**ADDENDUM TO THE
FINAL SAMPLING AND ANALYSIS PLAN
(Field Sampling Plan and Quality Assurance Project Plan)
Revision 0
February 19, 2004**

**TIME-CRITICAL REMOVAL ACTION AT THE
MARINE CORPS FIRING RANGE AND HISTORIC OUTFALL 4S
AT THE FORMER
MARE ISLAND NAVAL SHIPYARD
VALLEJO, CALIFORNIA**

DCN: FWSD-RAC-04-1044

FIGURE 1
PROPOSED SITE CHARACTERIZATION
SAMPLING LOCATIONS
MARINE CORPS FIRING RANGE
FORMER MARE ISLAND NAVAL SHIPYARD
VALLEJO, CA

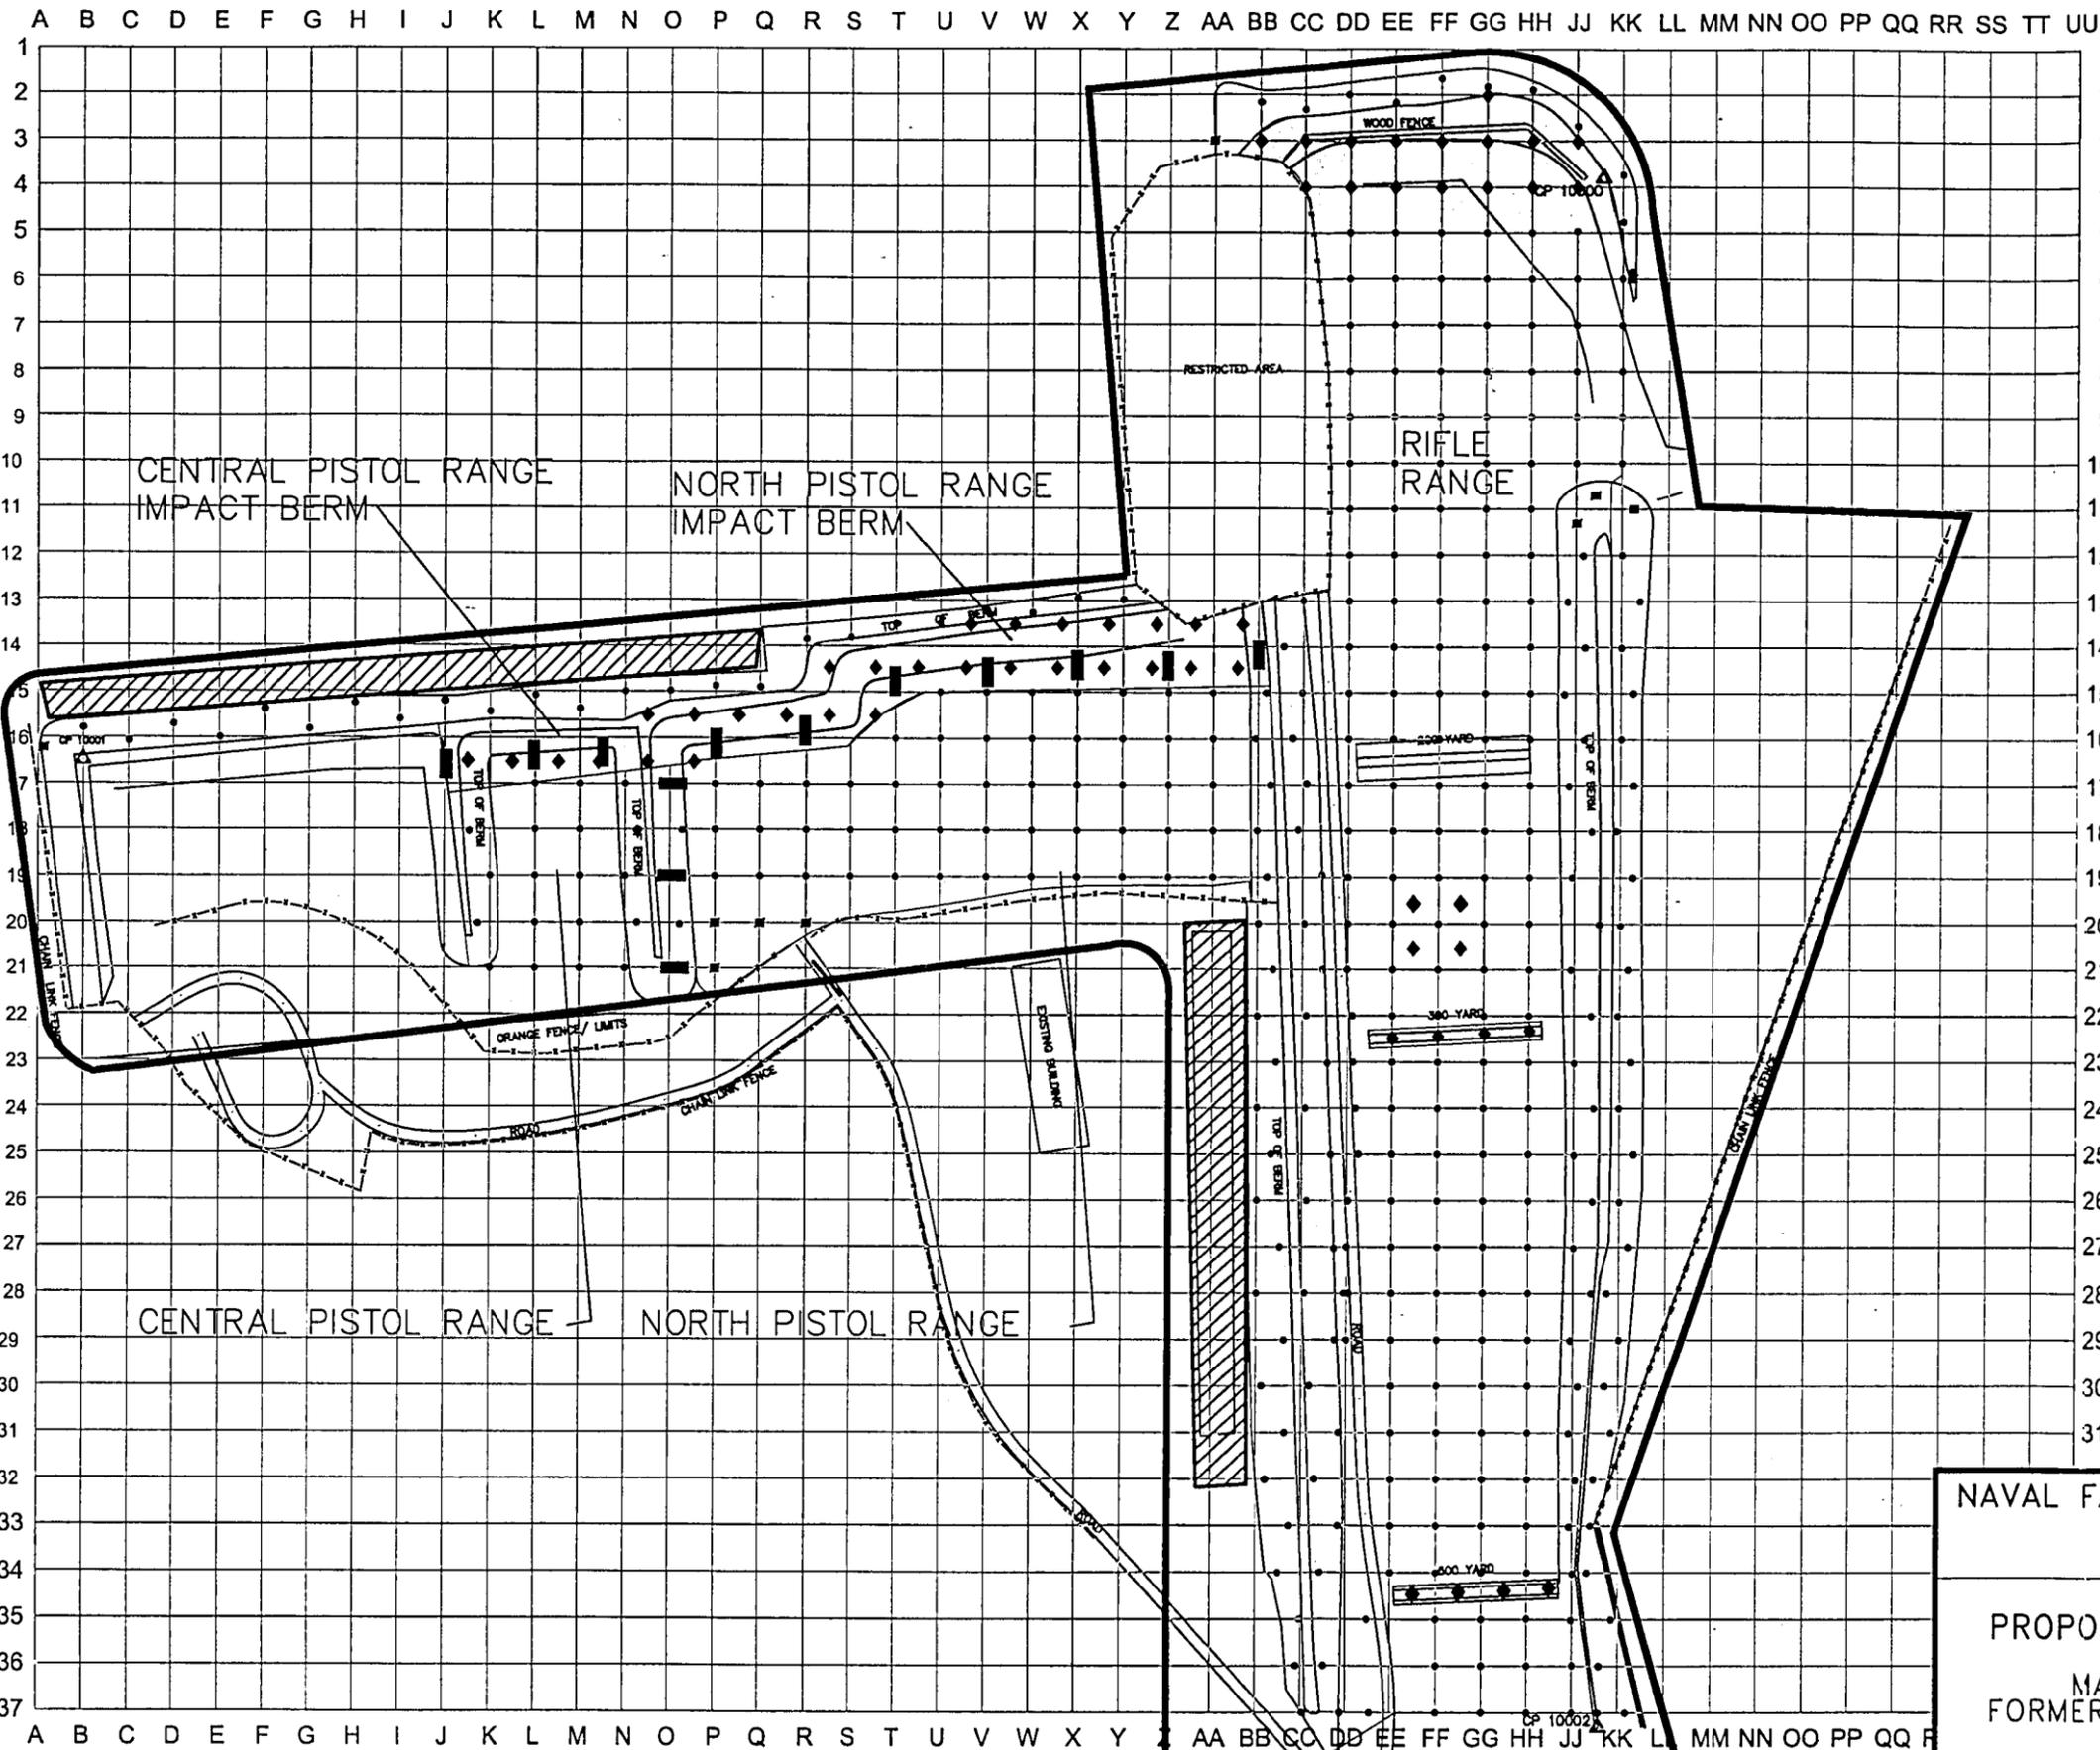
- Figure 1 Proposed Site Characterization Sampling Locations

Site characterization soil samples will be collected at the MCFR to assess whether the area has been impacted by past operations. The area will be divided into 50-foot by 50-foot grids (see Figure 1). Low-risk and high-risk areas have also been identified in Figure 1 as to the probability for site contamination based on past sampling and historic knowledge of the site. In addition, a portion of the North and Central Pistol Range berms as identified in Figure 1 will be trenched at 100-foot intervals prior to sampling to identify the portion of the old berm that was theorized to be covered over by a new berm. The trenches will be inspected for visible evidence of the old berm and bullet fragments and then sampled.
